New River Crossing Feasibility Review

Mike Mooney, PhD PE

Consultant to City of Fort Lauderdale

Vertical alignment and geotechnical profile

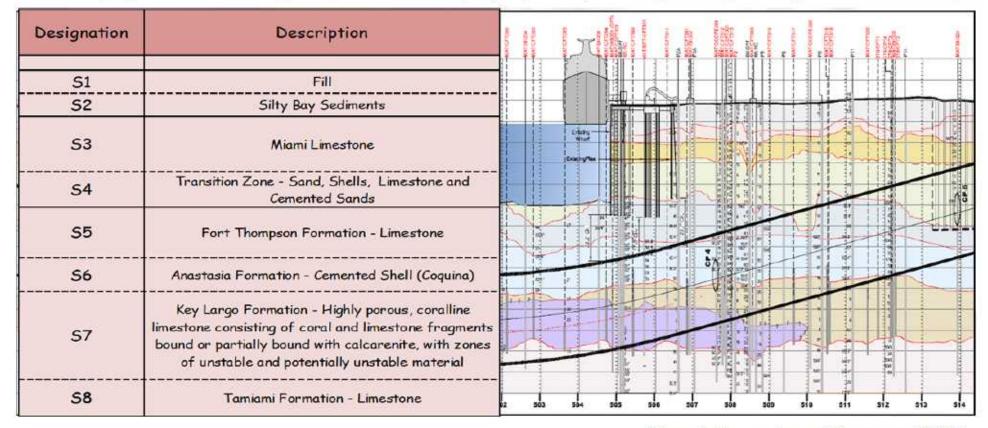
Challenging ~30 ft thick Key Largo Formation (S7) layer required injection grouting before tunneling

Coraline limestone not present in existing boreholes in New River tunnel area. Further geotech site investigation required.
